**1 DETAILS OF THE DEVELOPMENT**

Ref: 19/03679/PRE  
Location: 96-98 George Street, Croydon, CR0 1PJ  
Ward: Fairfield  
Description: Proposed demolition of existing buildings. Redevelopment to provide 11 storey building comprising office (Class B1 use) with ground floor cafe/restaurant (Class A1/A3 use)  
Drawing Nos: Submitted documents  
Applicant: Freshwater Group  
Agent: JLL  
Case Officer: Louise Tucker

Image 4: proposed ground floor plan

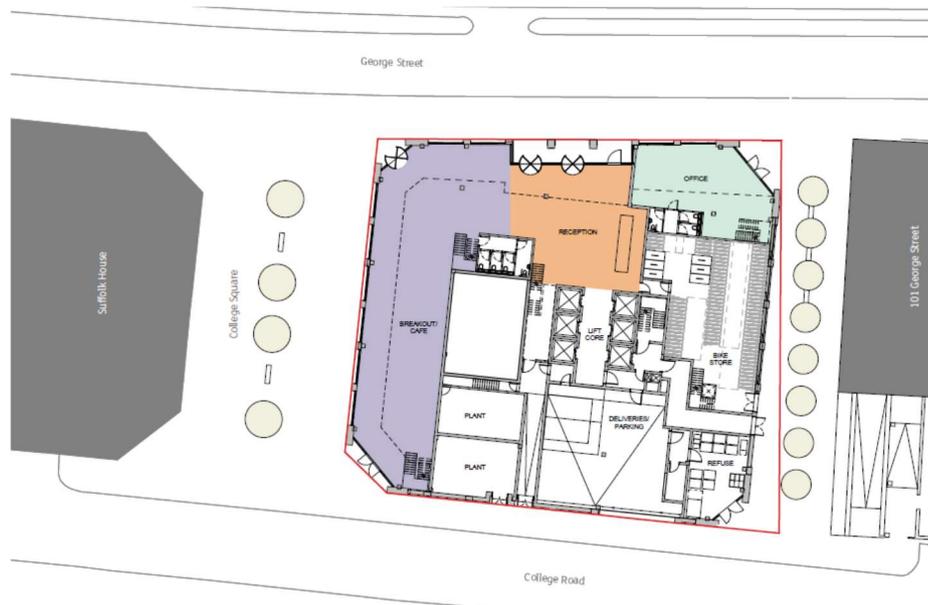
6.21 A new vehicular access is proposed off College Road, serving a parking and servicing area with 2 disabled parking spaces. This provision is considered appropriate given the highly accessible location and commercial uses proposed. Exact arrangements for the access are to be agreed to ensure safe access and manoeuvring can be achieved.

6.22 Refuse storage would also be to the rear off College Road, with collection arrangements and management strategy to be agreed. A dedicated cycle store is also proposed for users of the building, accessed on the eastern side of the building adjacent to 101 George Street, the principle of which is supported to further activate this space. The designs of this the cycle store are developing positively, development of the eastern façade and wind testing to ensure the space is a pleasant and usable space to support this will be important considerations going forward.

Image 9: CGI showing proposed scheme in its context (looking south)

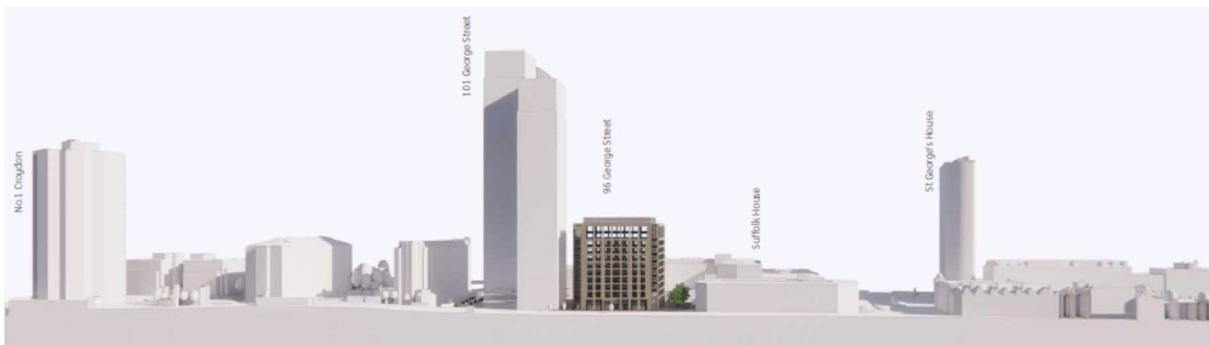
- 6.9 The proposed scheme is for an 11 storey building, utilising the majority of the site footprint with chamfered corners. The proposed massing seeks to mediate between the scales of 101 George Street and Suffolk House on either side, and the opposite Locally Listed Buildings on George Street (71-79 George Street to the north) and College Road (Croydon College to the south) respectively. Coupled with this is the need to balance the height and width of the building with the amenity impact on adjoining flank residential windows on 101 George Street (further detail below), and the requirement for large open plan floorplates to accommodate high quality office accommodation.

- 6.10 Whilst officers consider that a smaller footprint would be beneficial from a townscape and amenity perspective, we are cognoscente of the need for larger open plan floorplates for office developments. Taking these parameters into account, officers consider that the proposed massing could be appropriate, subject to further testing of the alternative options (including microclimate testing) and analysis of key townscape views (including the relationship with the Locally Listed assets and Locally Designated View looking east from North End to ensure harm is minimised). Feedback from the PRP suggested alternative massing options should be tested, and felt that a taller mass with a smaller footprint may be more appropriate in achieving a more slender form which is set away from the neighbouring windows. Members' views are sought.

Image 10: Developing bay studies of the façade

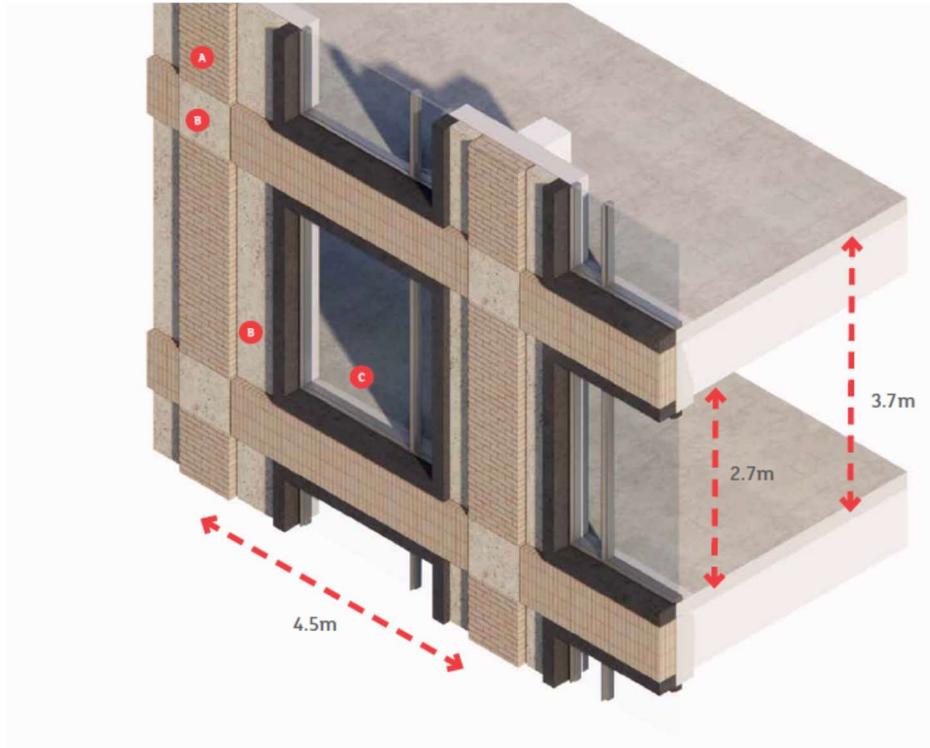
- 6.11 The design approach is focussed on incorporating Croydon typologies in the vicinity of the site which is supported in principle. This includes the rhythm and expression of Croydon's mid-century heritage, but also smaller scale Victorian heritage such as the Locally Listed buildings opposite. This is currently emerging as a woven approach to the façade, incorporating a regular grid expression with masonry in varying bonds and concrete feature panels. Officers are working with the applicant to ensure this concept is strongly articulated on the façade with differentiation expressed between the top, middle and base of the building and

elements of expressive character to give points of interruption and interest within the quite regimented elevations. It is also important to ensure the elevations achieve a vertical emphasis including development of the chamfered corners with the rest of the facade, particularly given the wide footprint proposed. These elements are currently under development, but officers consider that this is moving in a positive direction.

Image 12: surrounding context

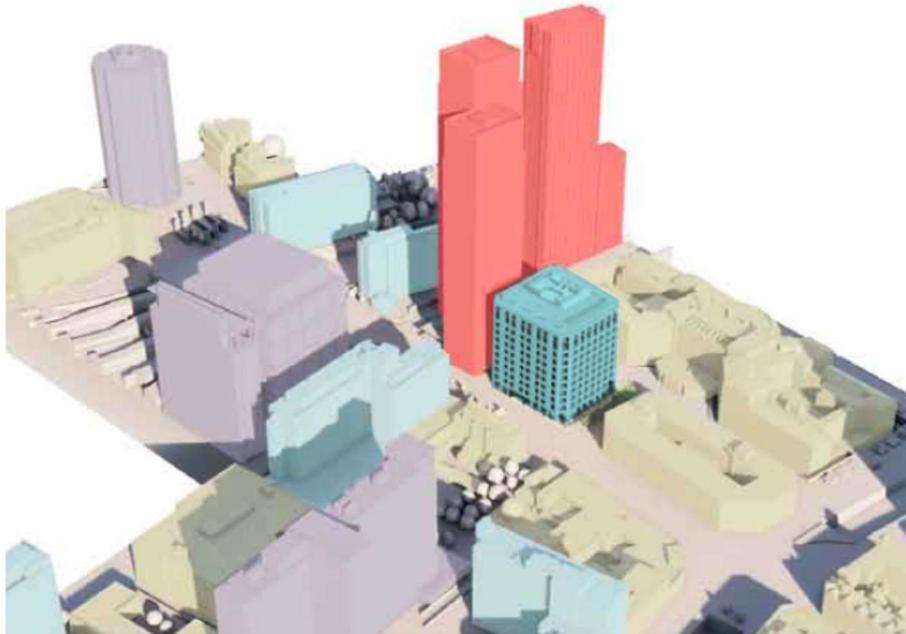
6.18 101 George Street has flank primary habitable room windows facing the site which, the applicant's initial analysis suggests, would experience material daylight/sunlight impacts. It is important to acknowledge however that the 101 George Street scheme was recently consented, with the principle of a mid-rise block on this pre-application site established and the site allocations envisaging future redevelopment. Therefore, whilst the impact is a concern that will need to be carefully considered, it is noted that some degree of flexibility will be required in this respect to allow a redevelopment to come forward. Officers are working with the applicants to understand the extent of the impact and potential remediation, and through this, understanding the optimal building massing and design (along with consideration of the townscape impact and key views).

6.19 The applicant's initial daylight and sunlight testing also identifies impacts to varying degrees for the residential units on the upper floors of 71-79 George Street (nos. 77 and 79 George Street being most severely impacted). As above, officers have requested the full results and analysis to understand the full impact and which windows are affected. It is appreciated that there will be some degree of impact with any larger building on the site and the dense urban nature is acknowledged. This will need to be weighed against the extent of the impact and potential mitigation, alongside whether the scheme delivers sufficient public benefit.
